STEERING COLUMN COVER HARDWARE REPLACEMENT

Prevost vehicles

On the vehicles affected by this bulletin, the existing lower steering column cover hardware has to be replaced for improved fastening system.

FIGURE 3 – L.H. AND FRONT SIDE

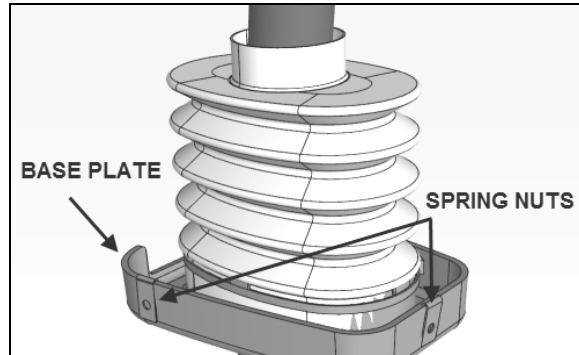
- 4) Install three (3) spring nuts #500684 as shown at the three existing holes found on the base plate (figure 3, 4 & 5).

FIGURE 5

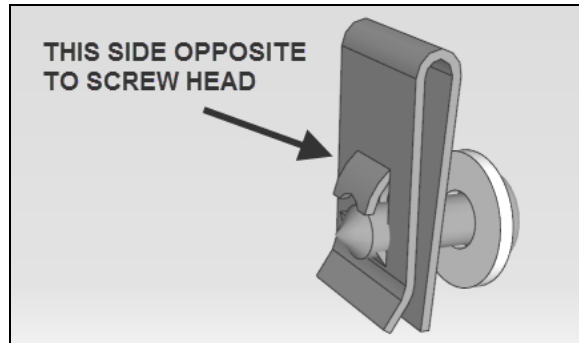
- 5) The tabs on the spring nuts must be located at the opposite side of the screw head (figure 5).

FIGURE 6 – 3rd FASTENING POINT NOT VISIBLE ON THE IMAGE

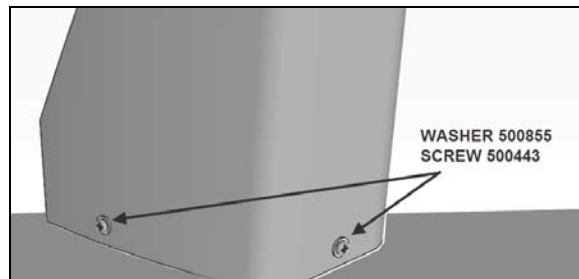
- 6) Reinstall the lower plastic cover, replacing each former trim panel fastener with:
1x screw #500443,
1x washer #500855

(see figure 6)
